**SUNDRY NOTICES AND REPORTS ON WELLS**  
*Do not use this form for proposals to drill or to re-enter an abandoned well. Use form 3160-3 (APD) for such proposals.*

8. Well Name and No.  
FLORANCE 18A

P&A Procedure  
BP America – FLORANCE 18A  
Blanco Mesaverde  
1675' FNL & 950' FWL, Section 11, T30N, R9W, San Juan County, NM  
API 30-045-22120

Re: Permanent Abandonment  
Well: Florance 18A

Proposed P&A

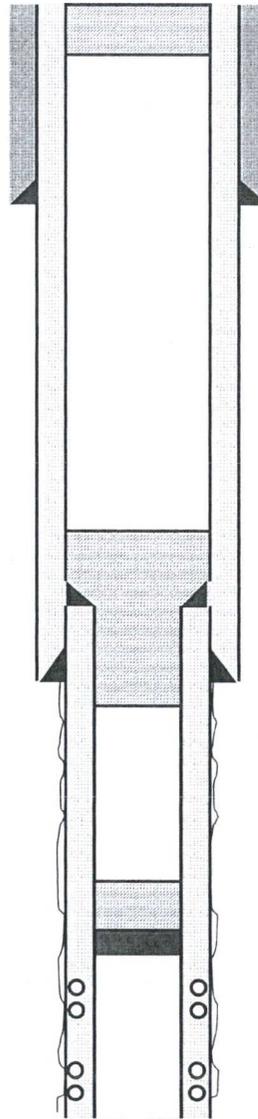
1. Plugging operations authorized are subject to the attached "General Requirements for Permanent Abandonment of Wells on Federal and Indian Lease."
2. Farmington Office is to be notified at least 24 hours before the plugging operations commence (505) 564-7750.
3. The following modifications to your plugging program are to be made:
  - a) Add a cement plug (3522 – 3422) ft. to cover the Chacra top. BLM picks top of Chacra at 3472 ft.
  - b) Set Plug 2 (3060 – 2360) ft. to cover the Liner, Pictured Cliffs, and Fruitland tops. BLM picks top of Pictured Cliffs at 2743 ft. BLM picks top of Fruitland at 2410 ft.
  - c) Set Plug 3 (1646 – 1369) ft. to cover the Kirtland and Ojo Alamo tops. BLM picks top of Kirtland at 1596 ft. BLM picks top of Ojo Alamo at 1419 ft.
  - d) Set Plug 3 (330 – 0) ft. to cover the surface casing shoe. Surface casing shoe at 280 ft.

You are also required to place cement excesses per 4.2 and 4.4 of the attached General Requirements.
